#### 33.2.7.4 Continuous output current capability in the POWER\_ON state

### 33.2.7.7 Output current at short circuit condition

**Replace Figure 33-14 by:**

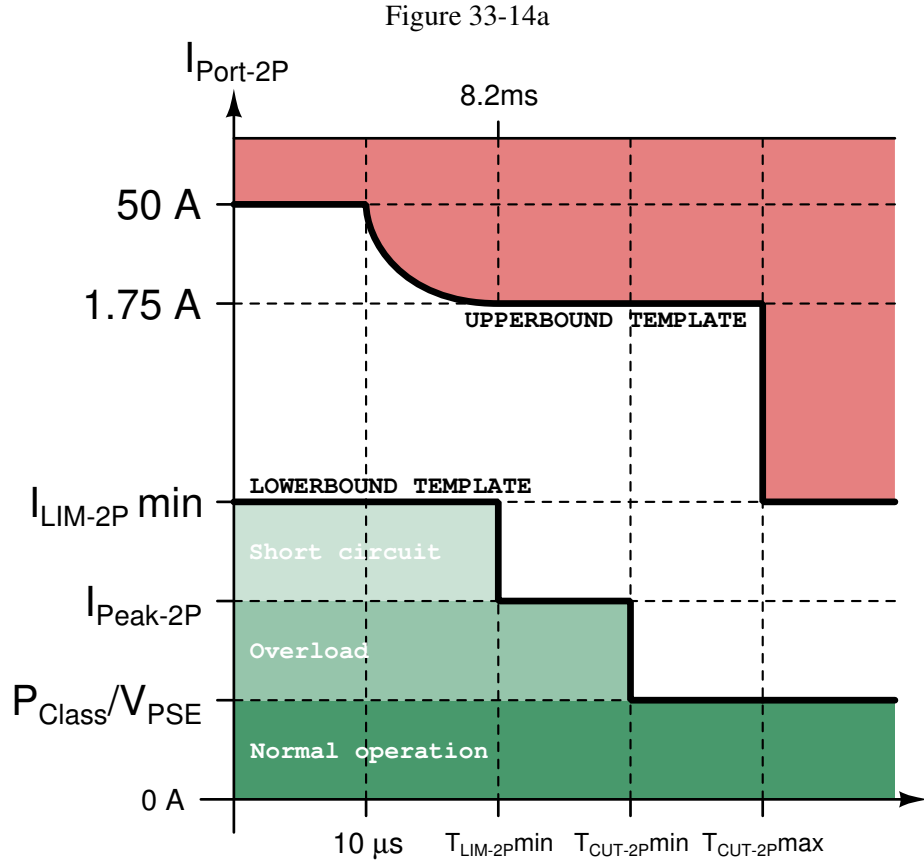
Equation 33-6a, Equation 33-7a and Figure 33-14a apply to PSEs that operate in 2-pair mode, as well as to Type 3 and Type 4 PSEs connected to dual-signature PDs.

$$I_{PSEUT-2P} = \left\{ \begin{array}{ll} 50 & \text{for } (0 \leq t < 10.0 \times 10^{-6}) \\ \sqrt{\frac{K}{t}} & \text{for } (10.0 \times 10^{-6} \leq t < 8.20 \times 10^{-3}) \\ 1.75 & \text{for } (T_{LIM-2P \min} \leq t < T_{CUT-2P \max}) \\ I_{LIM-2P \min} & \text{for } (T_{CUT-2P \max} \leq t) \end{array} \right\} \quad (33-6a)$$

$$I_{PSELT-2P} = \left\{ \begin{array}{ll} I_{LIM-2P \min} & \text{for } (0 \leq t < T_{LIM-2P \min}) \\ I_{Peak-2P} & \text{for } (T_{LIM-2P \min} \leq t < T_{CUT-2P \min}) \\ I_{Con} & \text{for } (T_{CUT-2P \min} \leq t) \end{array} \right\} \quad (33-7a)$$

Figure 33-14b

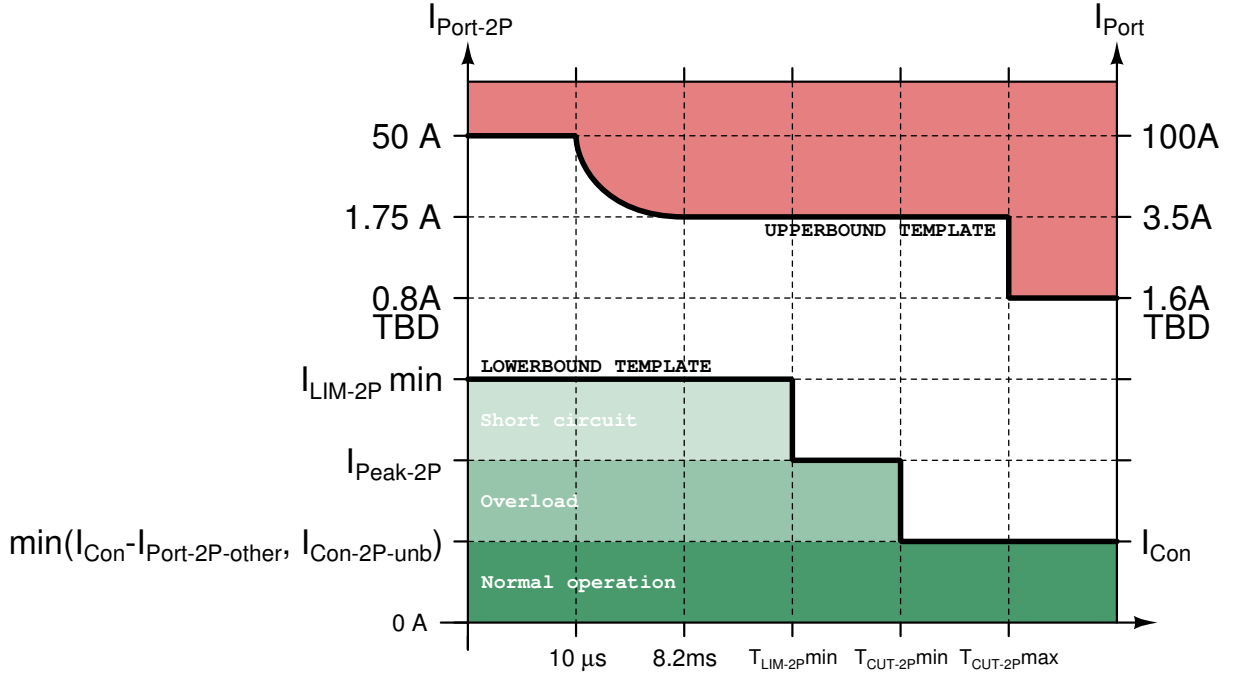
Equation 33-6b, Equation 33-7b and Figure 33-14b apply to Type 3 PSEs connected to single-signature PDs, operating in 4-pair mode.

$$I_{PSEUT-2P} = \left\{ \begin{array}{ll} 50 & \text{for } (0 \leq t < 10.0 \times 10^{-6}) \\ \sqrt{\frac{K}{t}} & \text{for } (10.0 \times 10^{-6} \leq t < 8.20 \times 10^{-3}) \\ 1.75 & \text{for } (8.20 \times 10^{-3} \leq t < T_{CUT-2P \max}) \\ 0.8 & \text{for } (T_{CUT-2P \max} \leq t) \end{array} \right\} \quad (33-6b)$$

$$I_{PSELT-2P} = \left\{ \begin{array}{ll} I_{LIM-2P \min} & \text{for } (0 \leq t < T_{LIM-2P \min}) \\ I_{Peak-2P} & \text{for } (T_{LIM-2P \min} \leq t < T_{CUT-2P \min}) \\ \min(I_{Con} - I_{Port-2P-other}, I_{Con-2P-unb}) & \text{for } (T_{CUT-2P \min} \leq t) \end{array} \right\} \quad (33-7b)$$

Figure 33-14c

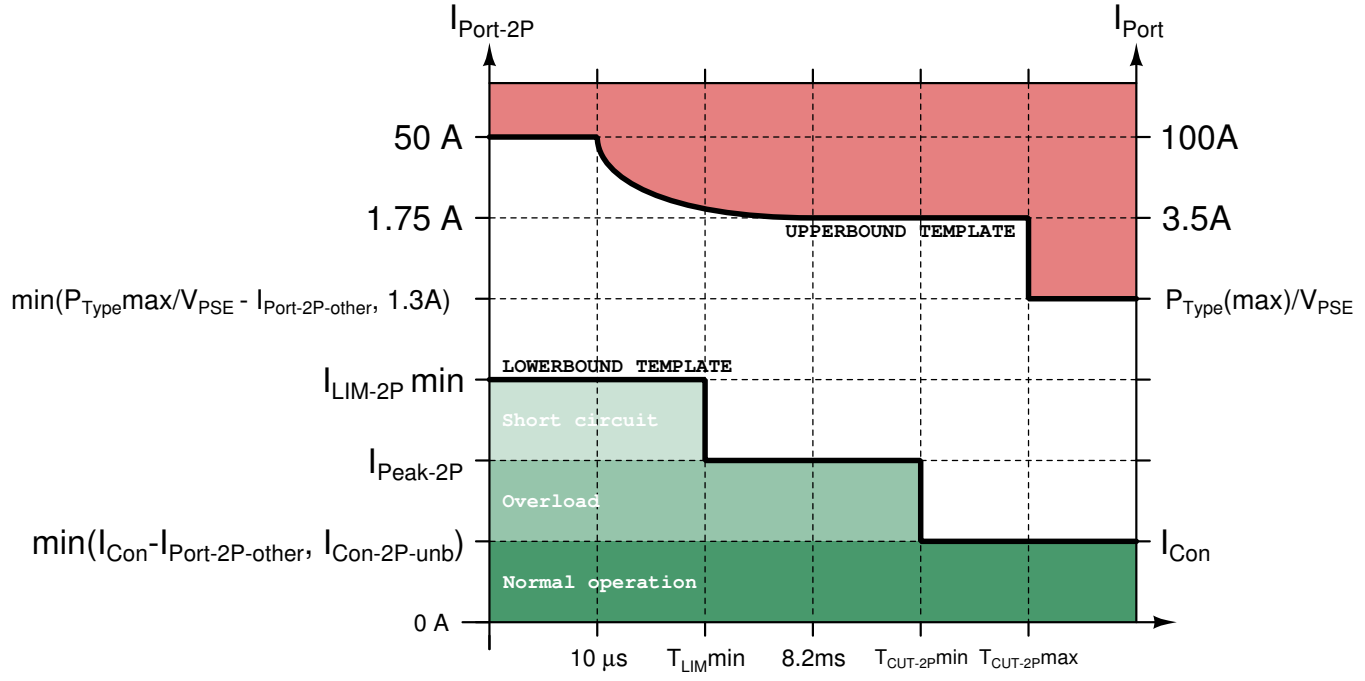
Equation 33-6c, Equation 33-7c and Figure 33-14c apply to Type 4 PSEs connected to single-signature PDs, operating in 4-pair mode.

$$I_{\text{PSEUT-2P}} = \left\{ \begin{array}{ll} 50 & \text{for } (0 \leq t < 10.0 \times 10^{-6}) \\ \sqrt{\frac{K}{t}} & \text{for } (10.0 \times 10^{-6} \leq t < 8.20 \times 10^{-3}) \\ 1.75 & \text{for } (8.20 \times 10^{-3} \leq t < T_{\text{CUT-2P max}}) \\ \min\left(\frac{P_{\text{Type max}}}{V_{\text{PSE}}} - I_{\text{Port-2P-other}}, 1.3\right) & \text{for } (T_{\text{CUT-2P max}} \leq t) \end{array} \right\} \quad (33-6c)$$

$$I_{\text{PSELT-2P}} = \left\{ \begin{array}{ll} I_{\text{LIM-2P min}} & \text{for } (0 \leq t < T_{\text{LIM-2P min}}) \\ I_{\text{Peak-2P}} & \text{for } (T_{\text{LIM-2P min}} \leq t < T_{\text{CUT-2P min}}) \\ \min(I_{\text{Con}} - I_{\text{Port-2P-other}}, I_{\text{Con-2P-unb}}) & \text{for } (T_{\text{CUT-2P min}} \leq t) \end{array} \right\} \quad (33-7c)$$
